LICENSEE: LOUISIANA POWER AND LIGHT COMPANY  
FACILITY: WATERFORD 3  
SUBJECT: BASEMAT - MEETING SUMMARY

The purpose of the meeting was to discuss the Confirmatory Analyses and Surveillance Programs for the Waterford Steam Electric Station, Unit 3 common foundation basemat.

PROGRAM  
TO  
PERFORM CONFIRMATORY ANALYSES  
NUCLEAR PLANT ISLAND STRUCTURE BASEMAT  
AT  
WATERFORD STEAM ELECTRIC STATION-UNIT NO 3  
LOUISIANA POWER AND LIGHT COMPANY

FIGURE 1

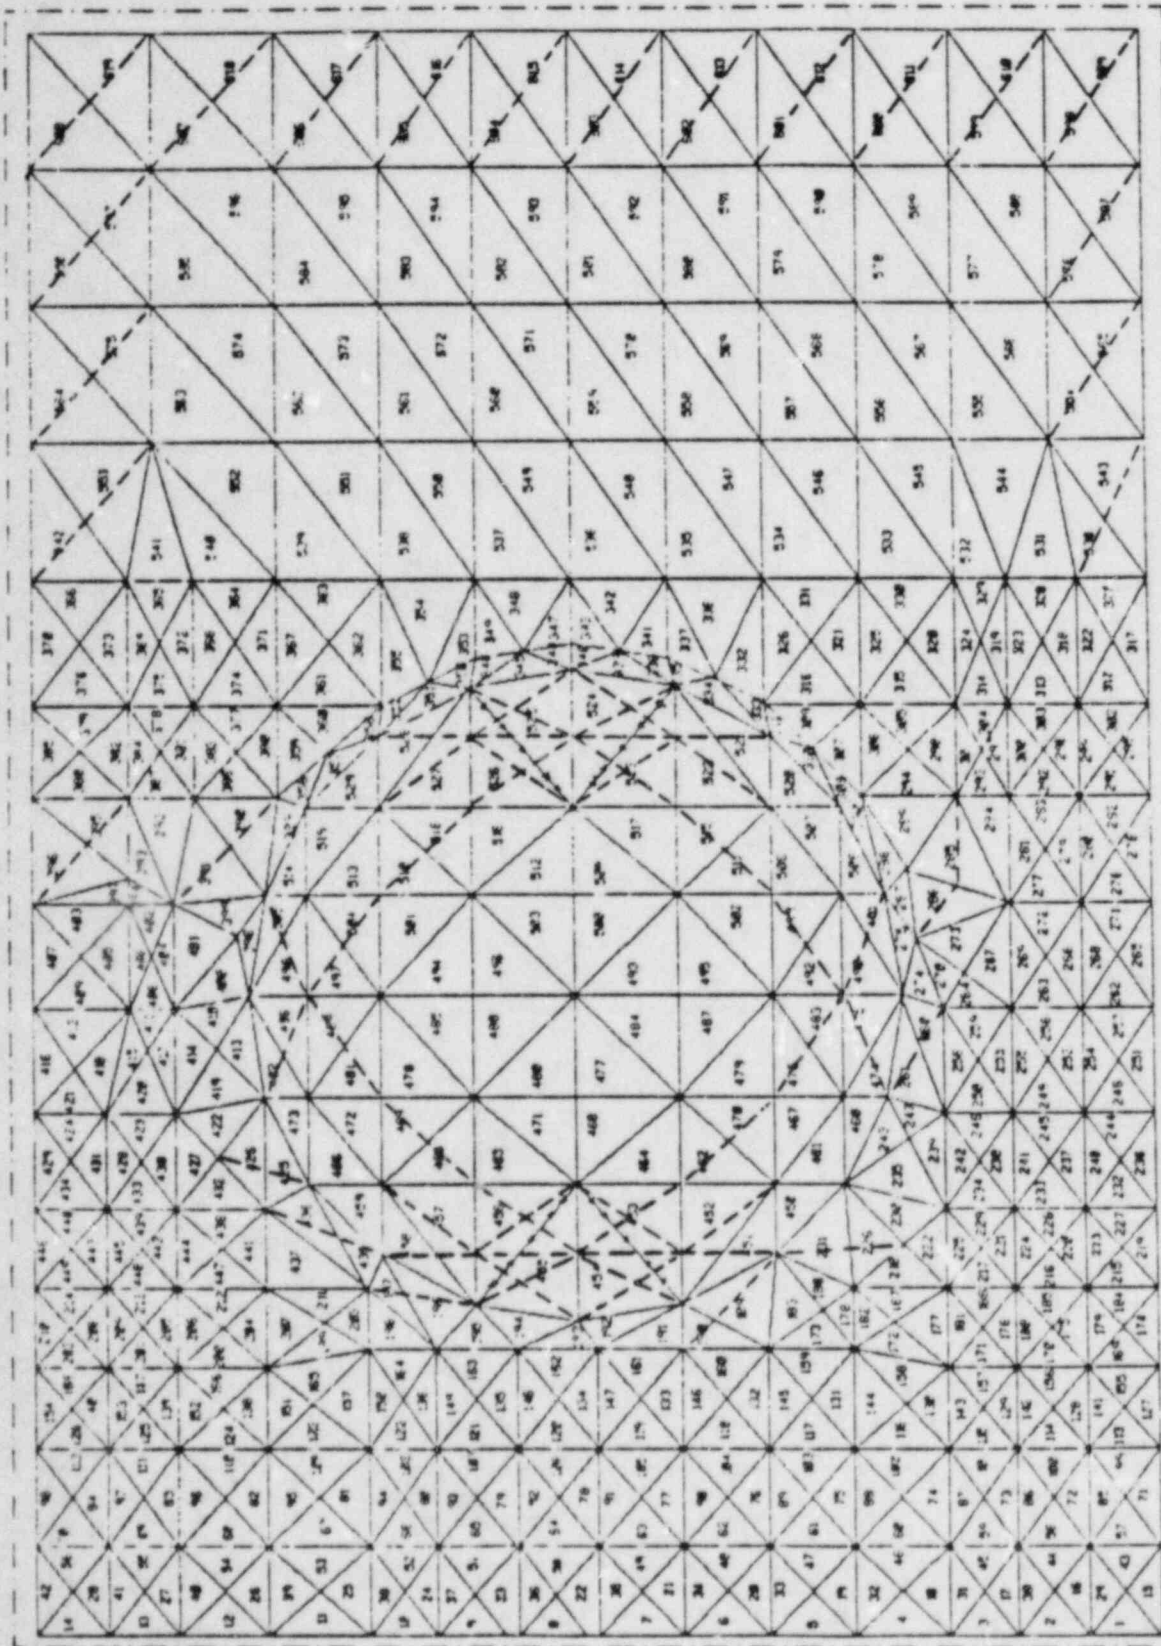
In addition, the staff felt that the finite element mesh, as presented at the meeting, required additional modification to further improve the fineness of the grid.

The existing STARDYNE model of the basemat will be modified as necessary to incorporate the finer element sizes. The areas which will be modified are areas in the vicinity of the Reactor Shield Building wall and areas forming the junction between the exterior walls of the NPIS and the basemat. Figure 1 shows the proposed modifications to the basemat finite element model mesh.
